**Attachment A:  
Predevelopment Plan Review  
Comments to Applicant**

PREDEVELOPMENT PLAN REVIEW COMMENTS

Project Number: PPR2019-00008
Date: October 3, 2019
Project Address: 491-577 South Arroyo Parkway
Project Description:

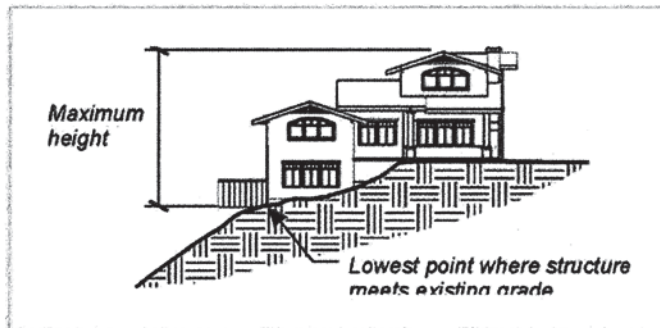
7. **Height (PMC 17.26.020.3.c(3) and 17.30.030)** Per the PD standards, in the CD district, no PD plan may authorize a greater height than that permitted by Figure 3-8 - Central District Maximum Height. The site is located in the CD district and Figure 3-8 establishes a height restriction of 50' for the site.

The project proposes heights of up to 90' and exceeds the established height standard of the zoning district. Although a PD Plan allows an applicant to prescribe its own development standards, it is recommended that the PD Plan height standards be similar to the existing development standards of the zoning district. The maximum 50' height requirement for the Arroyo Corridor/ Fair Oaks subdistrict, is reflective of the existing character of the surrounding area.

district and Figure 3-8 establishes a height restriction of 50' for the site. The project proposes heights of up to 90'.

In order to qualify for a Variance for Historic Resources, the structures need to be designated as historic resources. This process needs to be initiated through the Design & Historic Preservation Section. Only after the designation, can the Variance for Historic Resources be processed.
